Prepared for:
Art Gallery of New South Wales, Trusts
Date:
11 November 2021
Image:
produced by Kazuyo Sejima + Ryue
Nishizawa / SANAA (c) Art Gallery of
New South Wales, 2021

Section 4.55(1A) Modification – Minor Design Changes

Art Gallery of NSW Expansion Project – Sydney Modern

Figure 3 Proposed Site Plan – Drawing no. DA_1001

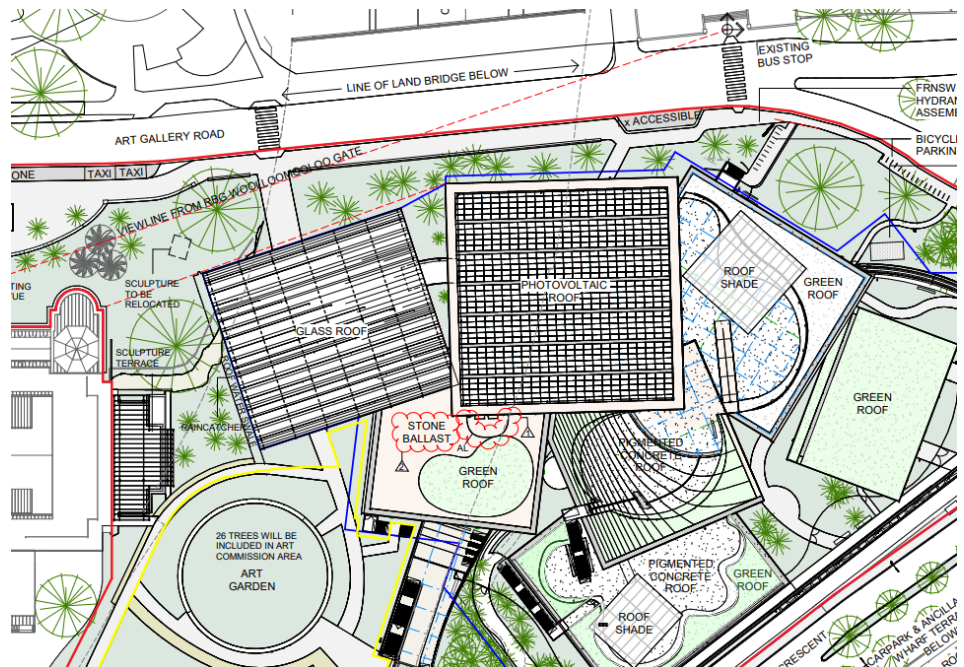
The Proposed Modification seeks to change from a 'passive' to an 'active' building pressurisation system, located within the Entry Pavilion (directly above the Gallery 1 entrance). The initial selection of a 'passive' building pressurisation system is highly dependent on external weather effects; hence, the switch to an 'active' building pressurisation system would allow for improved control over the temperature and humidity conditions within critically conditioned spaces, such as the gallery spaces.

It is proposed that a low height screen is added to conceal the building pressurisation system. The screen is to conceal the associated extraction fans, ductwork and dampers. The screen will be a solid acoustic screen 1000mm to 1050mm high with a level top, clad in aluminium, anodised or similar powdercoat colour. The height of the screen is lower than the height of the entry pavilion roof which sits directly north of Gallery 1 roof

The roof to Gallery 1 is proposed to be changed to a stone ballast roof in place of the previous pigmented concrete roof in this location. This has been done on the basis of cost and aesthetics. This roof is not trafficable except for maintenance purposes. The green roof component will remain unchanged.

Note that areas subject to this proposed modification are shown in red clouds.

Figure 5 Proposed East Elevation A – Drawing no. DA_3013
 Note that areas subject to this proposed modification are shown in red clouds.
 Source: SANAA and Architectus Architects (2021)

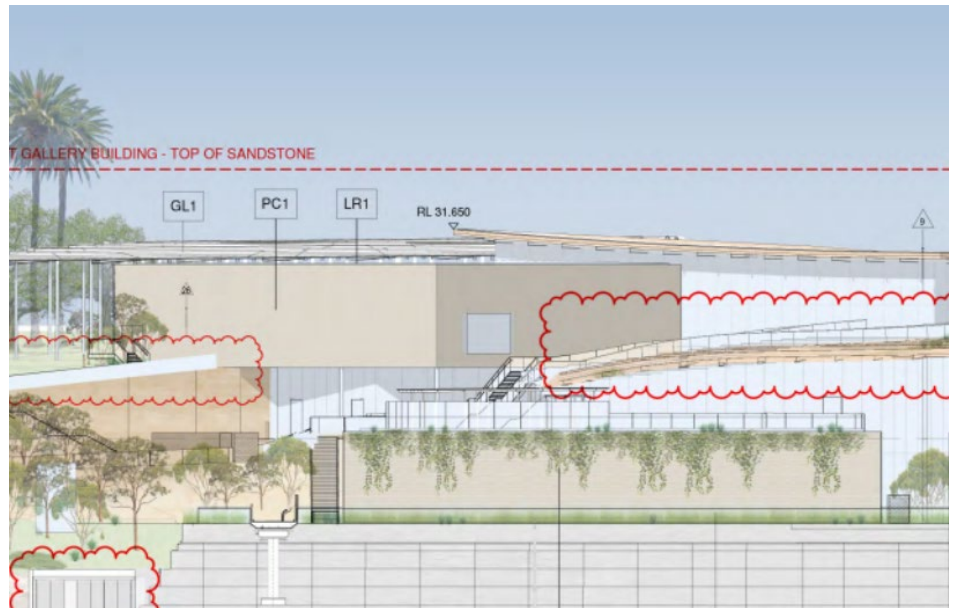
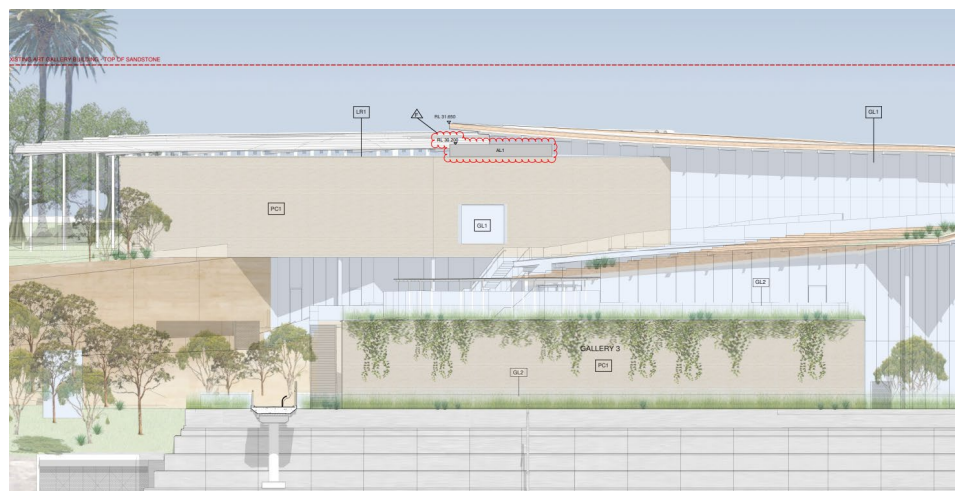
Figure 4 Approved East Elevation – Drawing no. DA_3001
 Note that red clouds were works part of Modification 5.
 Source: SANAA and Architectus Architects (2021)
